May 28, 2008

Re: Responses to Comments on the 95% Design  
Herrick Hollow Creek Restoration  
Richardson Hill Landfill Site

**Comments from USEPA, USFWS and NYSDEC  
Contained in USEPA's Letter Dated April 30, 2008**

**NOTE: TOPOGRAPHIC SURVEY PROVIDED BY KEYSTONE ASSOCIATES IN JULY 2007**

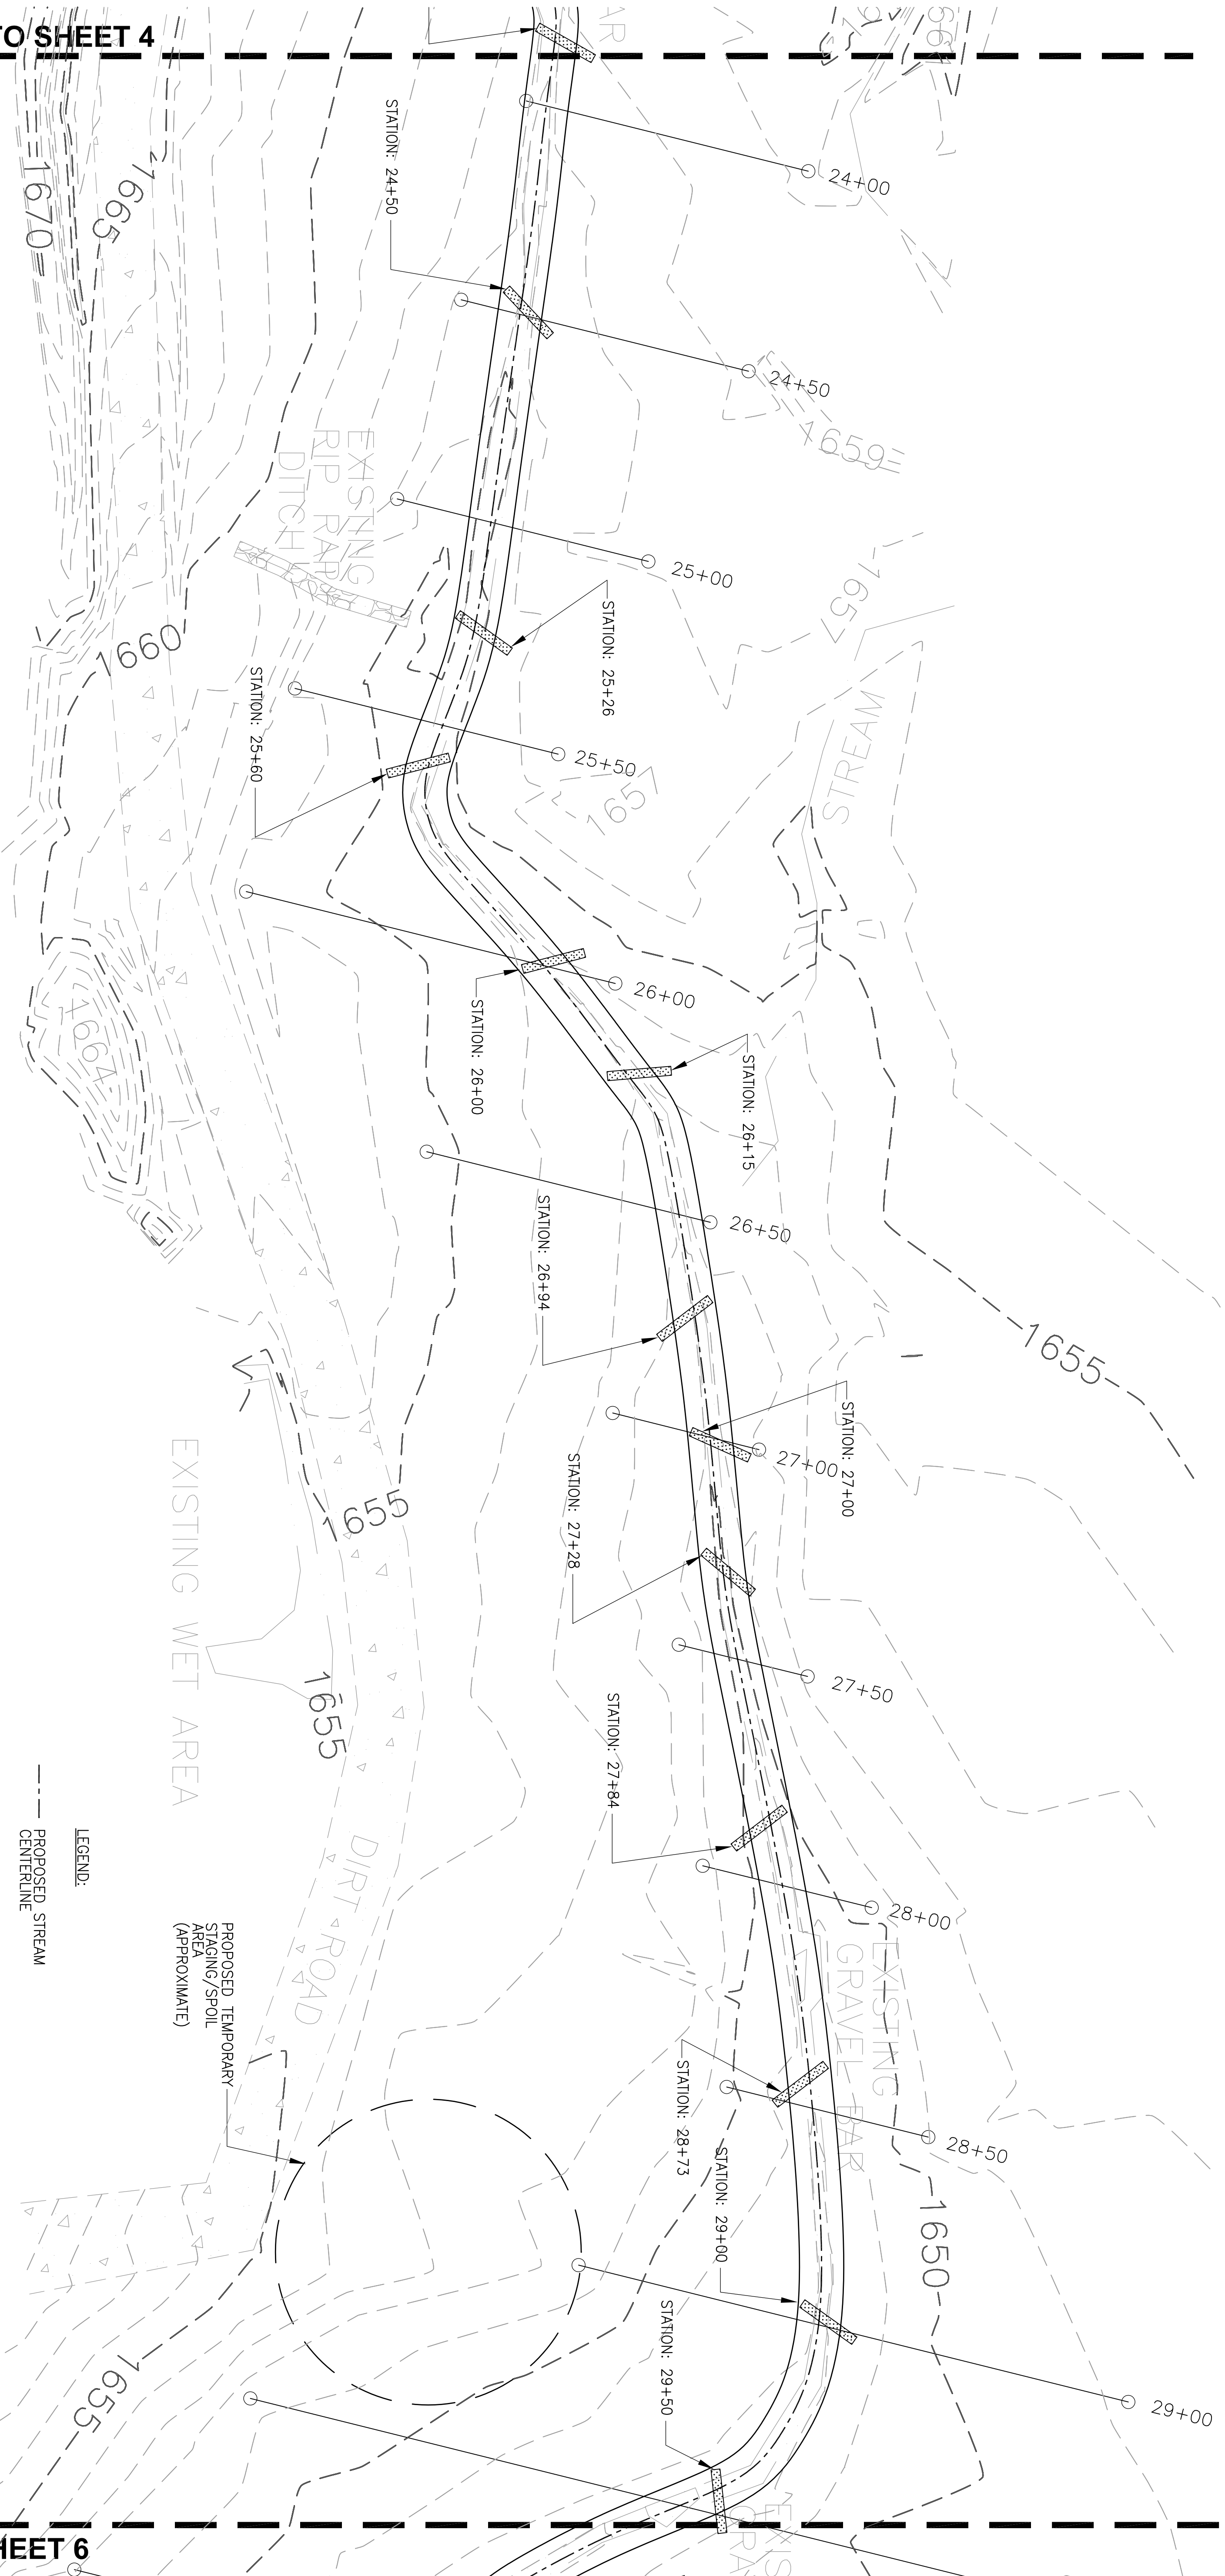
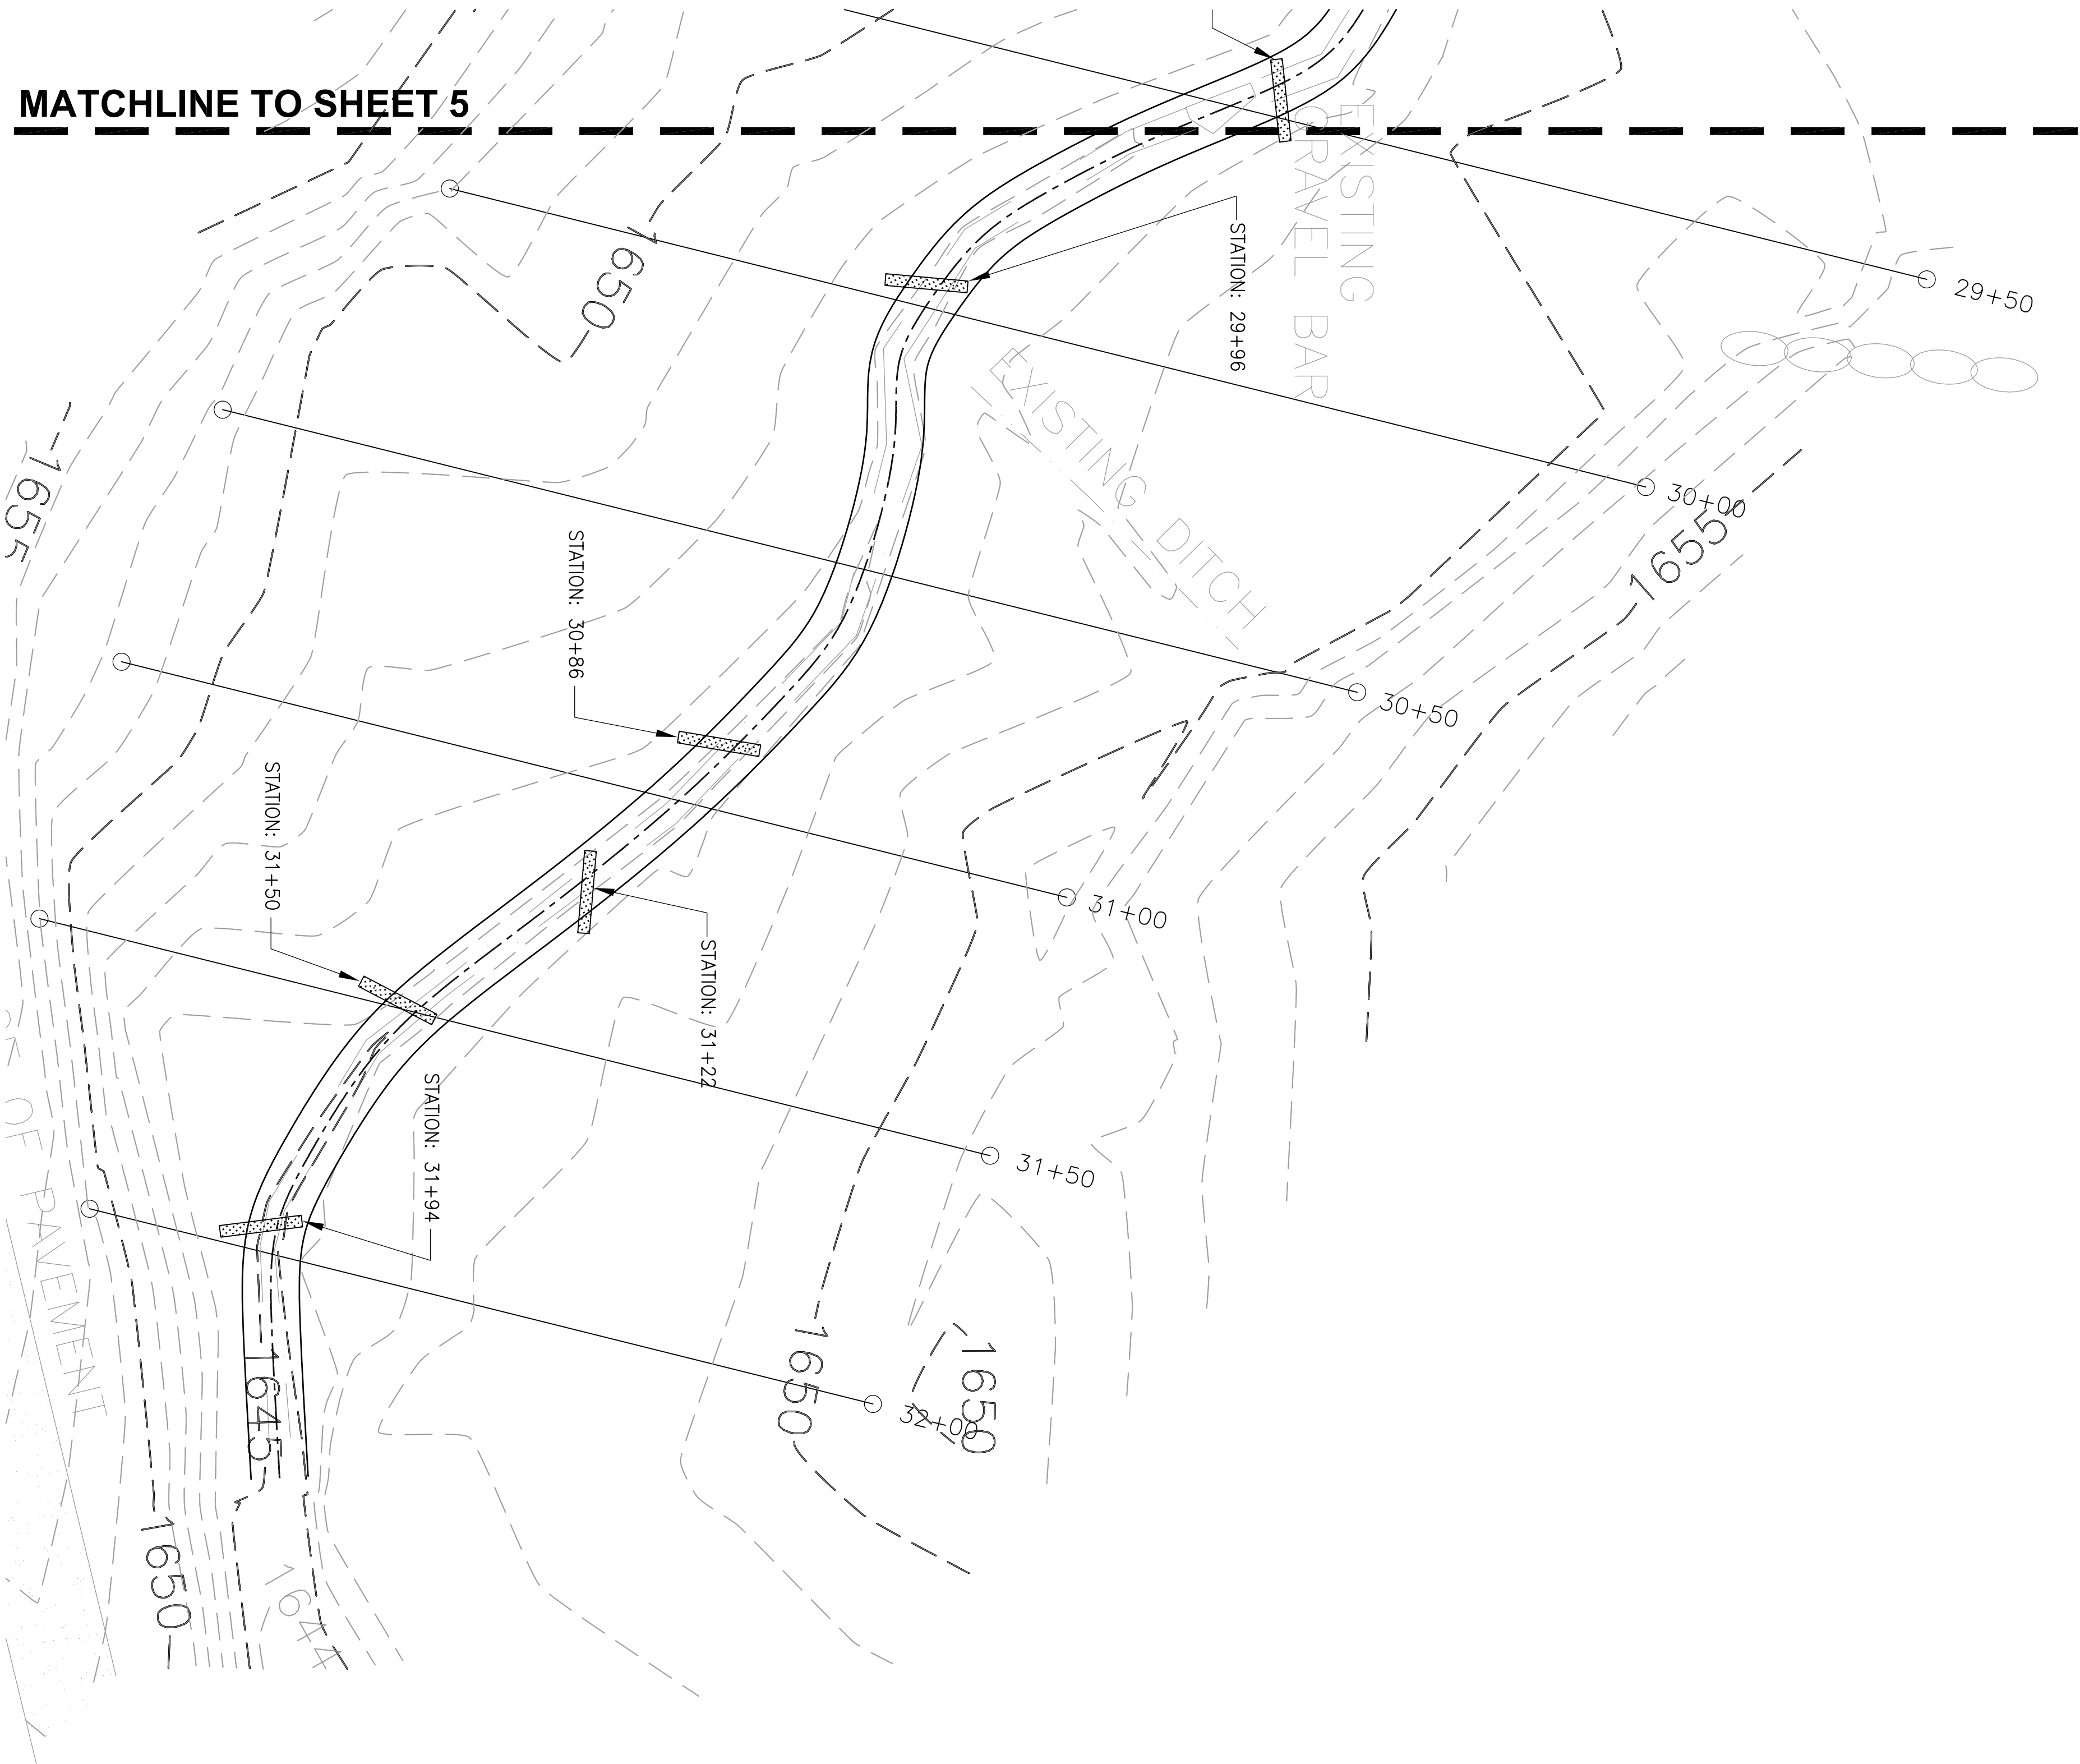
## **Sheets 15-18**

1. If log vanes and cross vanes have the same angle specifications (20-30 degrees from the bank and 4-7 degrees arm angle), and both start from bankfull elevation and end at invert elevation, how can log vanes span the entire channel while rock vane arms span 1/3 of bankfull channel? This needs careful consideration, particularly since designs show the entire lower channel from approximately 20+00 to 32+00 to contain only log vane structures. Please address design concern outlined.

2. Please justify the choice of log vane structures in this area vs. cross vanes or cascades. As noted in Specifications SR-12, these structures are designed to reduce shear stress on the banks. If the lowest point of the structure is at the tie-in to the bank, that location will be the thalweg and as such will be the point of greatest shear stress. These structures should therefore be redesigned to meet the invert away from the bank as for rock or cross vanes, or other structures should be used that better meet stated design goals.

3. Additional vegetative materials should be placed at banks upstream and downstream from log vane tie-in to prevent flanking.

*Response* – Item 2 below has been noted, and edits will be made to reflect that log vanes will be keyed into the streambed invert in the center of the channel (1/2 channel width). This change is relevant to the following response, which addresses Item #1

Manipulation of log vane and cross vane arm orientation within acceptable ranges (20-30 degrees from the bank and 4-7 degrees arm angle) allows for both log vanes and cross vanes to be installed in the manner prescribed. This is due to the narrow nature of the channel. Specifically, because the design channel width in Segment III (where log vanes are prescribed) is 10.6 feet, the difference between 1/3 channel width (3.5 feet) and 1/2 channel width (5.3 feet) is only 1.8 feet. Adhering to the range of allowable log vane orientation (20-30 degrees from bank and 4% to 7% arm slope angle) allows for the extension of the upstream invert of the log vane so that it can span 1/2 of the channel width (at 30 degree angle from bank and 4% arm angle, for instance), while a cross vane arm can adhere to the same acceptable range of orientation and span only 1/3 channel width (at something closer to 30° from bank and a 7% arm angle, for instance).

*Response* – Plans, details, and specifications (Construction Specification SR-12: Log Vane) have been edited to reflect the following change:

The upstream terminus of the log vanes will be located at mid-channel. The log vane shall be keyed into the streambed at the desired bed elevation so that the log vane spans 1/2 channel width. The log vane will only tie into the downstream outer bank (at the bankfull elevation) and into the upstream streambed invert at 1/2

the channel width. This will maintain the thalweg in the center, or just off center, of the channel.

The use of log vanes in Segment III was selected over other methods, such as cascades or cross vanes, because they are the least inhibitive method to fish passage, identified in the Goals and Objectives Memorandum as a primary consideration in the restoration design of the lower third (Segment III) of the stream reach to be reconstructed. Log vanes also provide a component of large woody debris (LWD) in the channel, identified in the Basis of Design Report as a significant physical component affecting form and function of the reference reaches. Addition of LWD in the lower third of the channel augments instream habitat.

*Response* – Substantial streambank treatments, including coir logs, coir mats, live stakes, and erosion control fabric are prescribed as bank treatments throughout the course of the restored channel. It is envisioned that, commensurate with the prescribed amending of streamside soils, a great deal of colonization from adjacent intact vegetation will occur. Even in the existing poor soil conditions we have seen rapid and extensive colonization of the riparian area by herbaceous and woody species since the last significant disturbance of the near channel area occurred in September '06.
